PLANNING COMMISSION
Regular Meeting
Monday, December 4, 2017
7:00 PM
Christine Nuernberg Hall

Agenda

TO: Planning Commission
FROM: JAC ZADER, ASSISTANT DIRECTOR COMMUNITY DEVELOPMENT
DATE: December 4, 2017
SUBJECT: Ranch Court, LLC for Christine Glass and Bill Frick. The applicant is seeking conditional use grant, preliminary plat and development agreement approval to allow for a single family subdivision consisting of 6 lots for the property located at 2100 W. Ranch Road.

PRELIMINARY PLAT
"RANCH COURT"

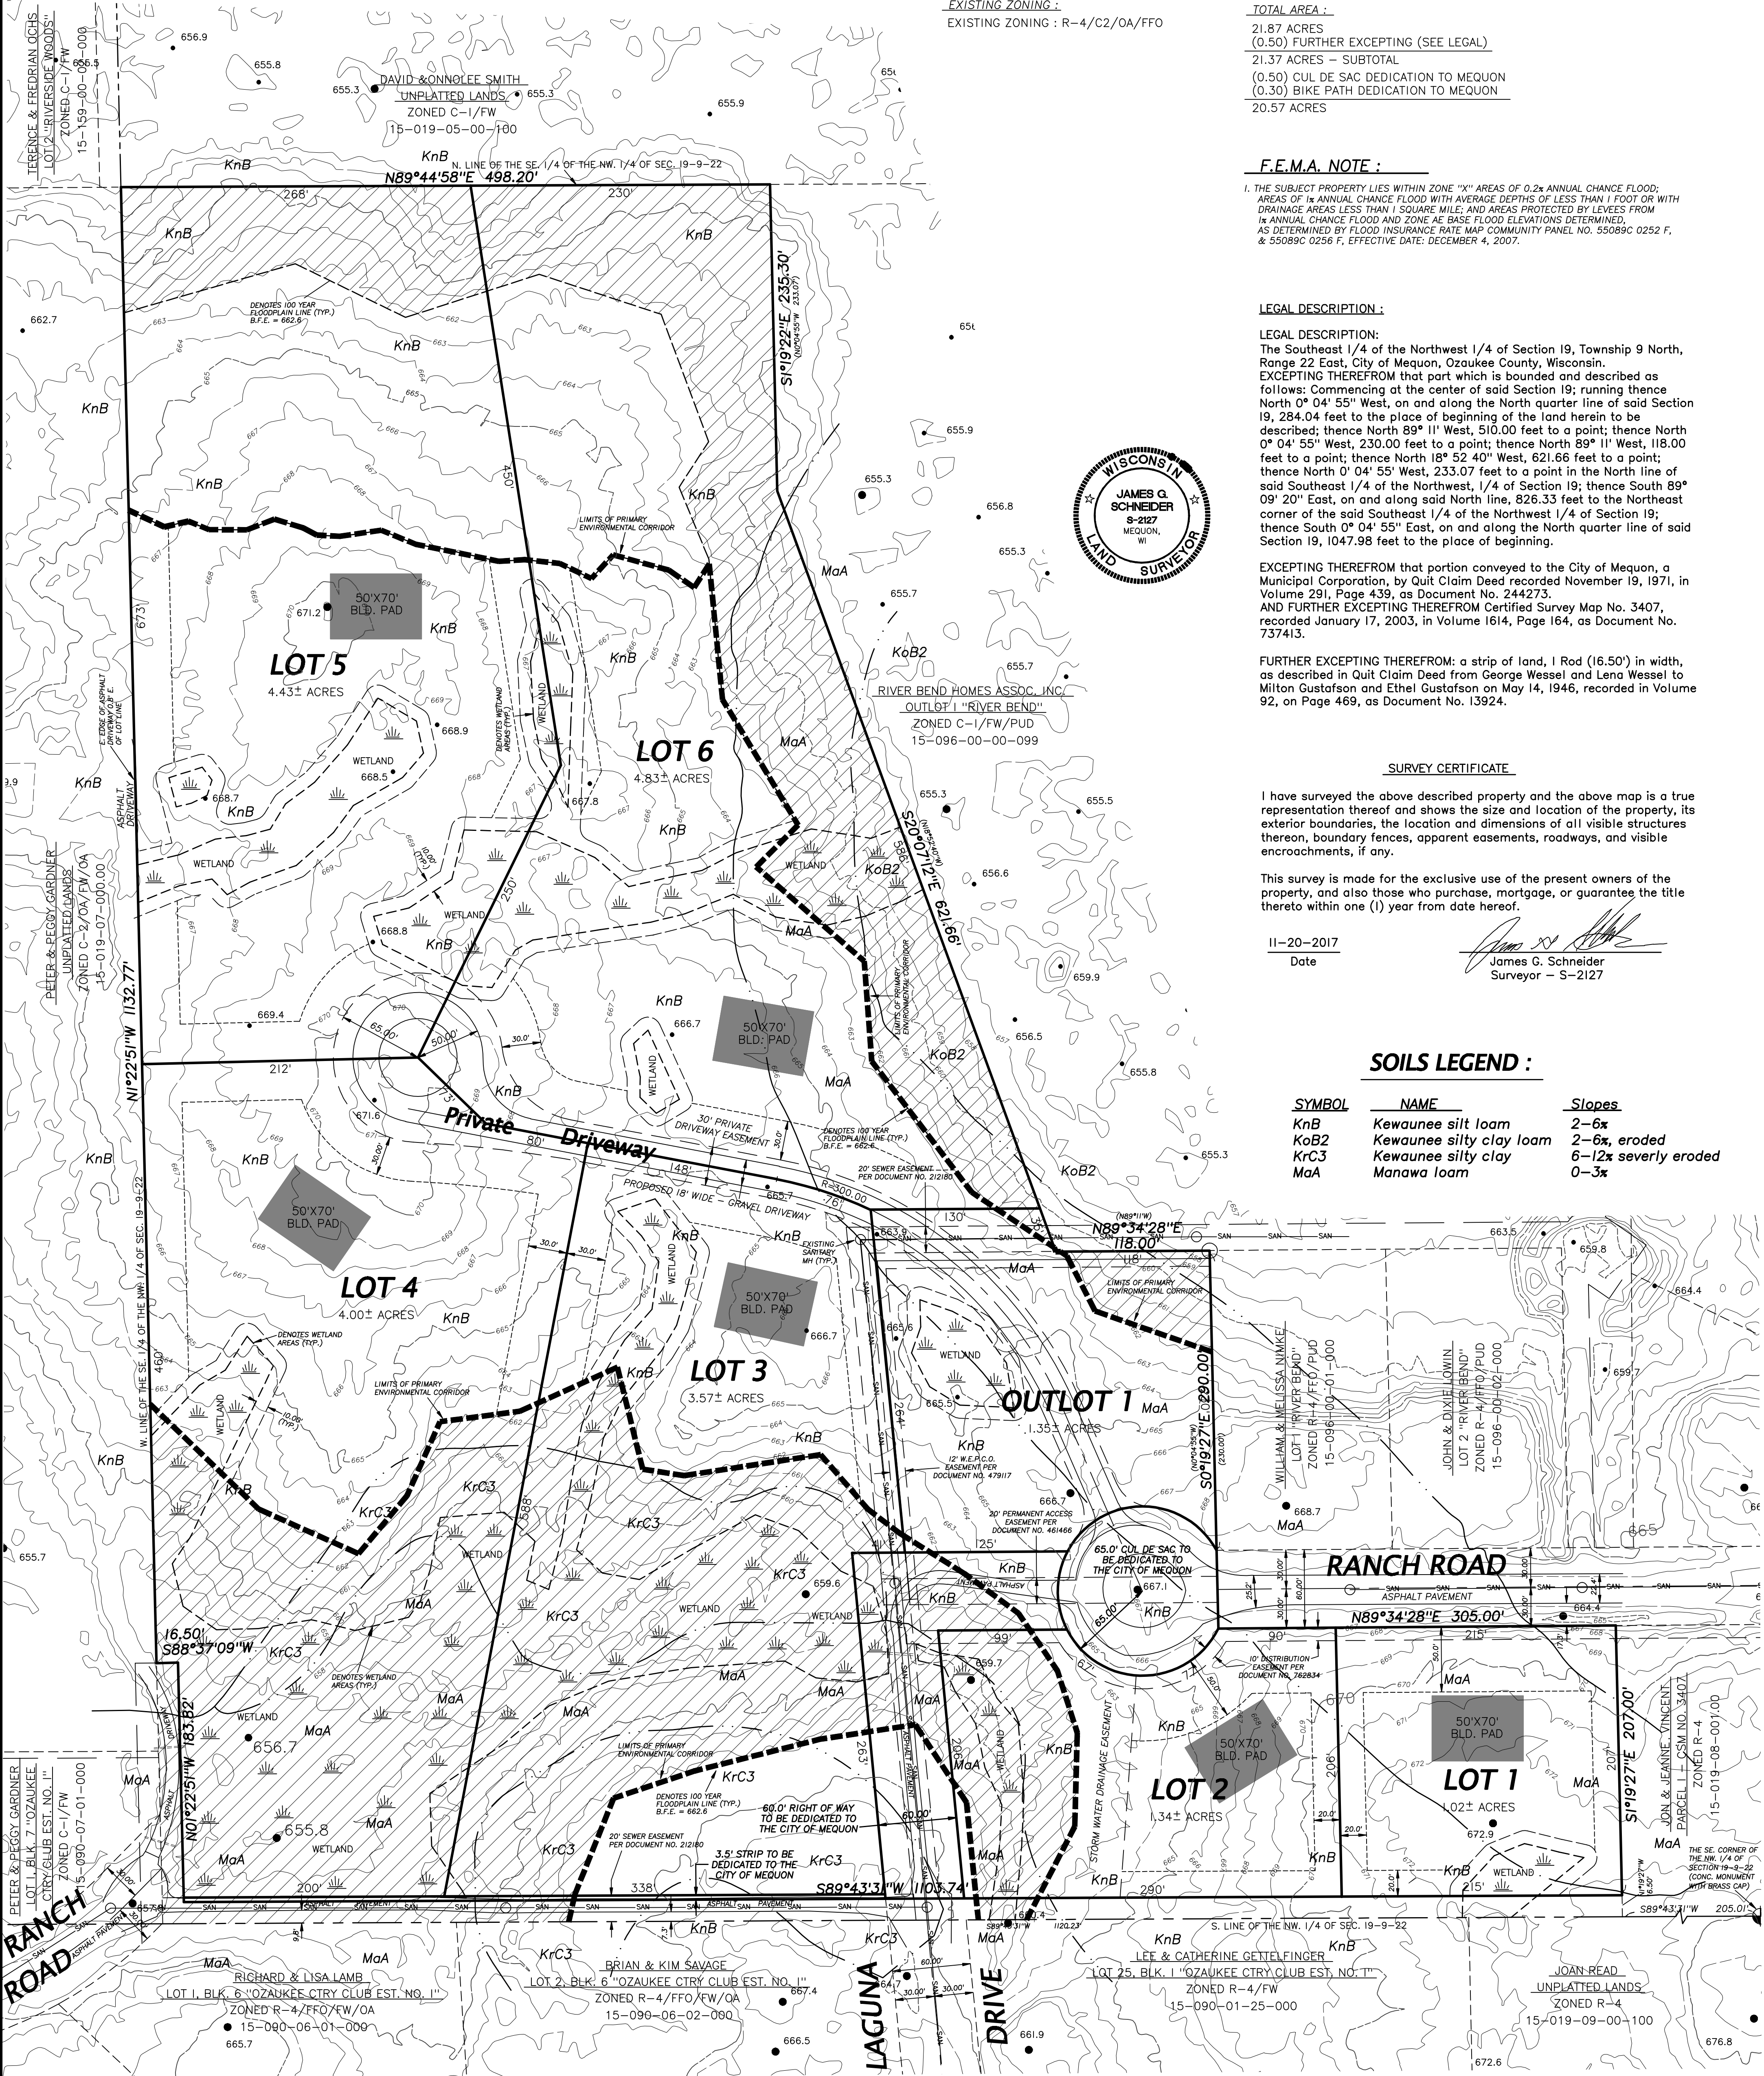
The conceptual plan details six lots and an outlot near Ranch Road and Laguna Drive. Lots 1 and 2 accessed off of Ranch Road. There is a proposed private drive serving lots 3, 4, 5, and 6. The cul-du-sac right-of-way on Ranch Road is shown to be 65-feet. The City standard right-of-way is 75-feet for a cul-du-sac.

A stormwater management plan (SWMP) is required for the site. The stormwater management calculations indicate that the proposed new impervious area is 0.914 acres, including the individual homesites. Any development increasing impervious surfaces by more than 0.5 acres require a SWMP that meet the City of Mequon, MMSD and WDNR criteria.

Planning staff recommends approval of the preliminary plat, development agreement and conditional use grant subject to the following condition(s):

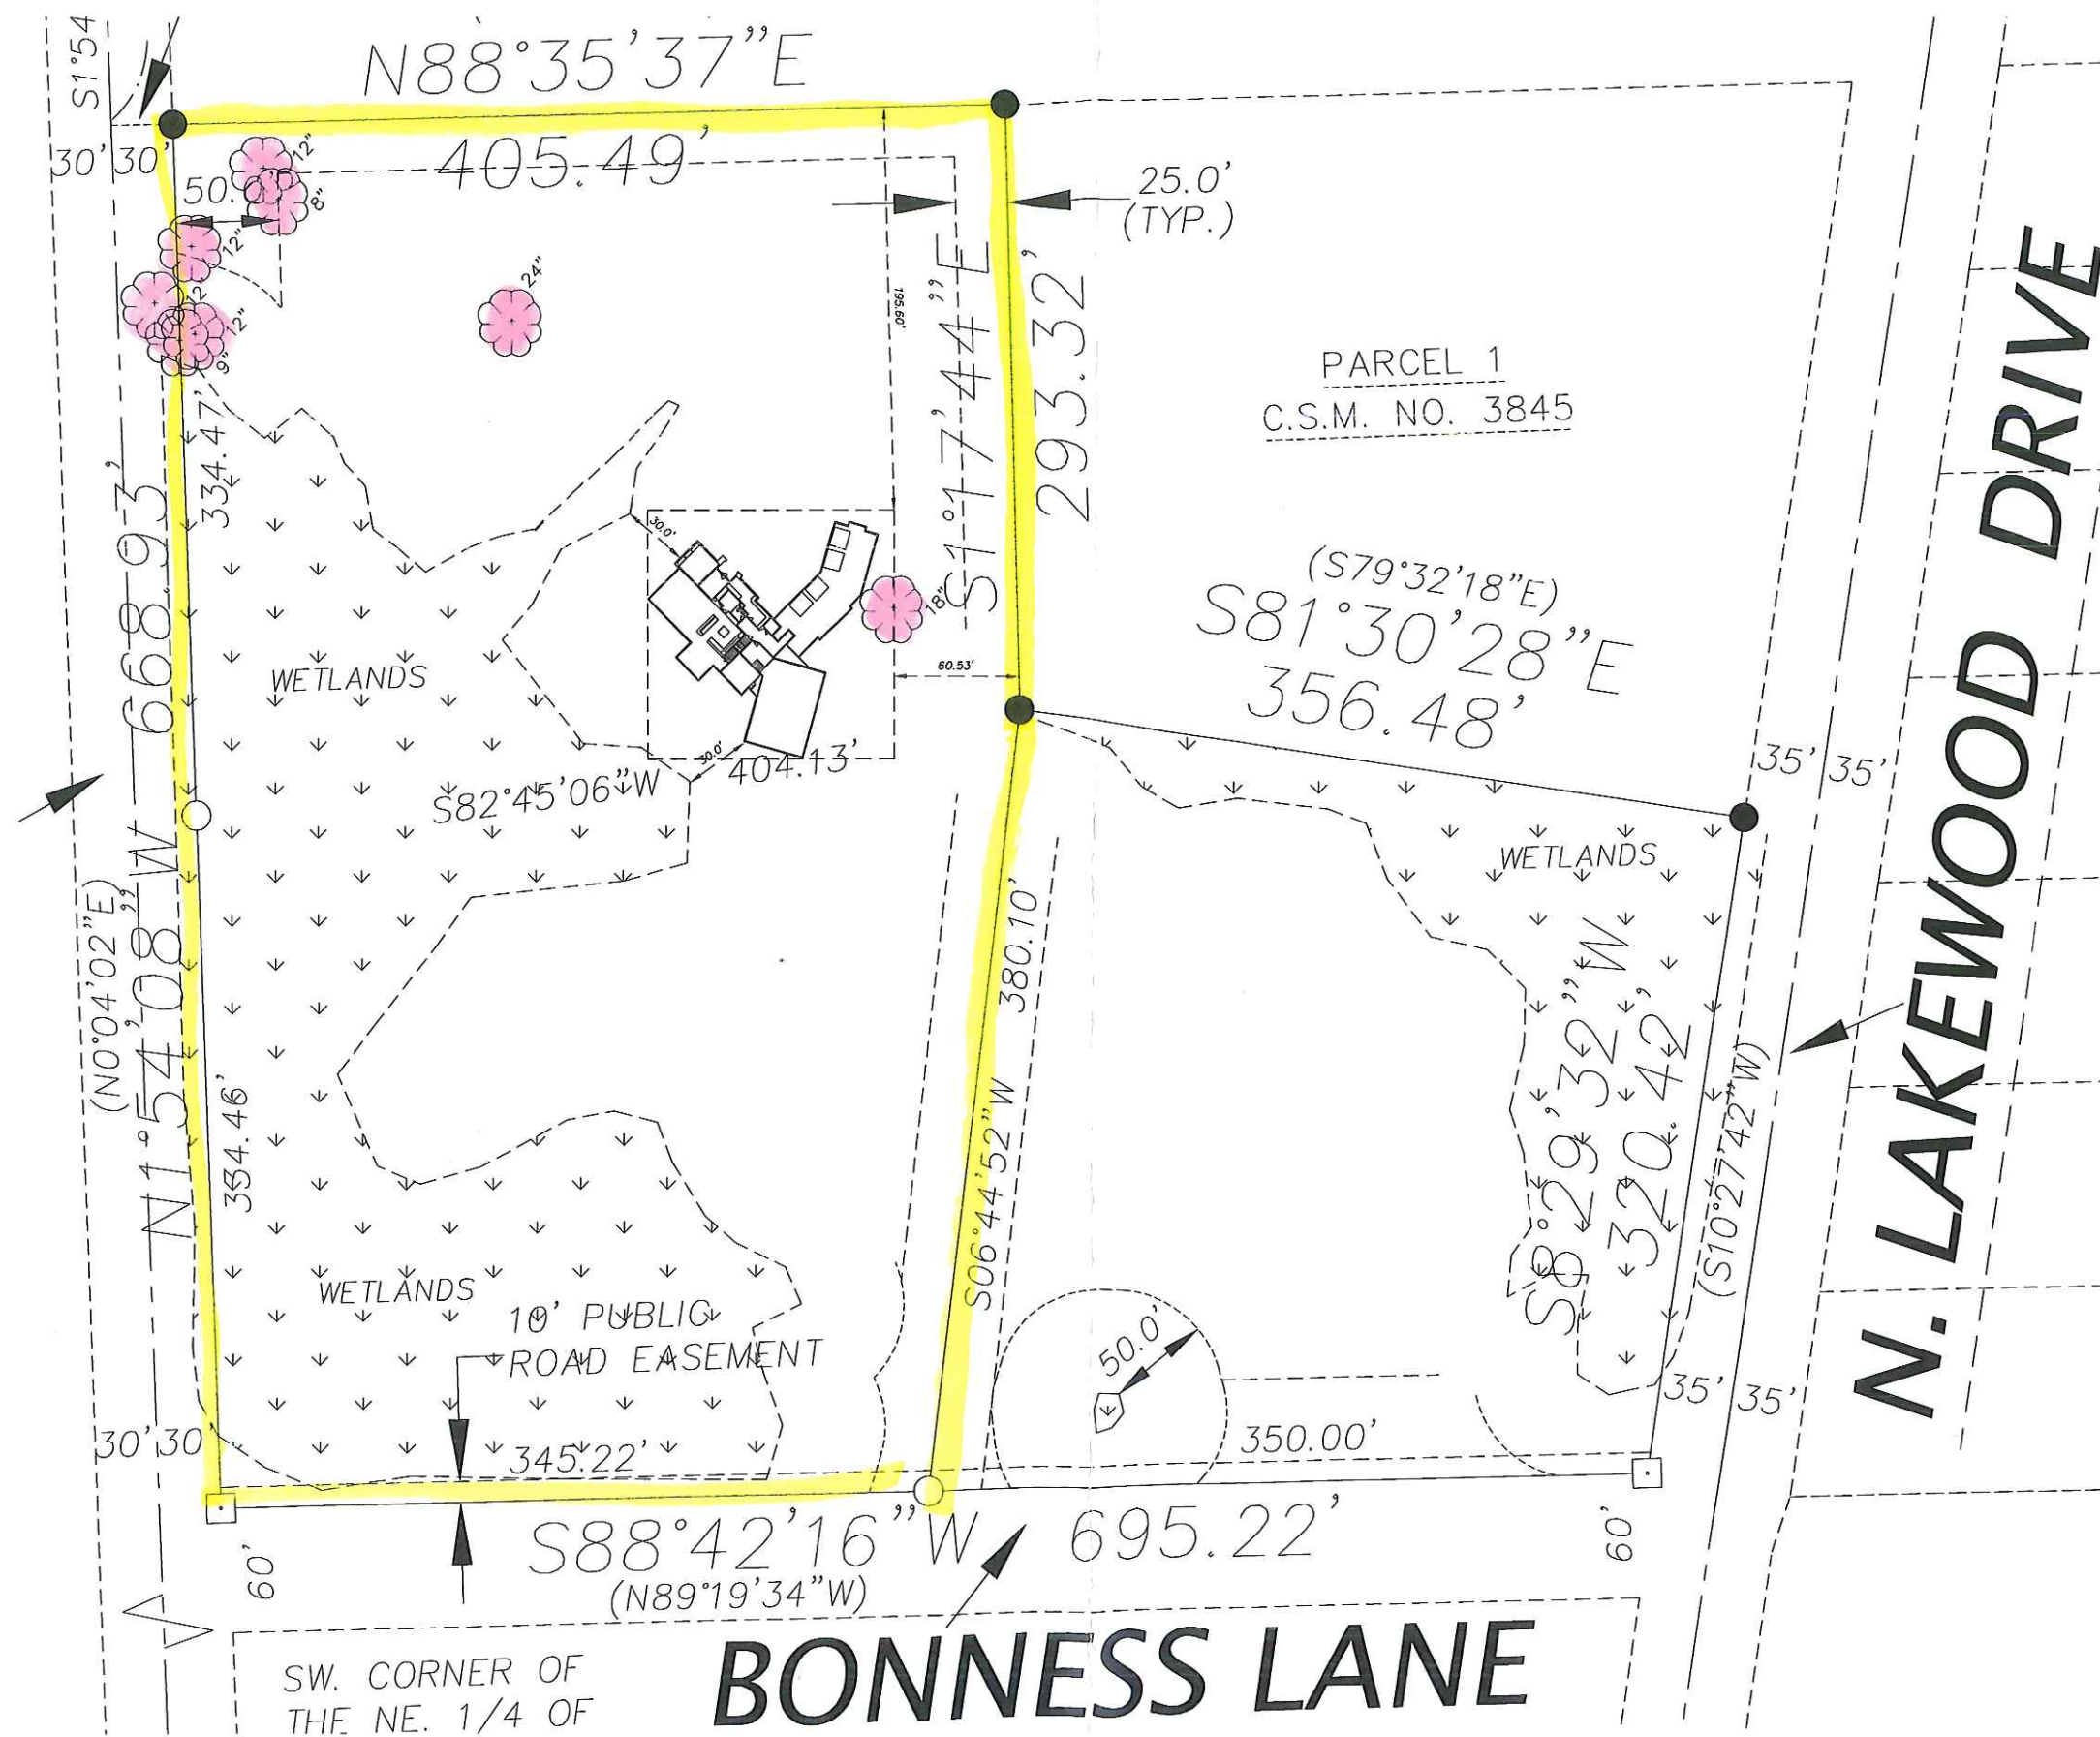
The only tree that would potentially need removal would be the (16") White Pine in the proposed footprint of the house. In discussing alternatives with Mr. Adams and the builders a conclusion that none of the three trees would have to be affected by construction if they're preferred location was approved. The preferred plan would allow the construction within a wetland setback and in turn preserve the tree in question.

The Forestry Department does not recommend removal of the White Pines. Staff would suggest a waiver be granted to allow encroachment into the wetland setback in order to preserve the trees.
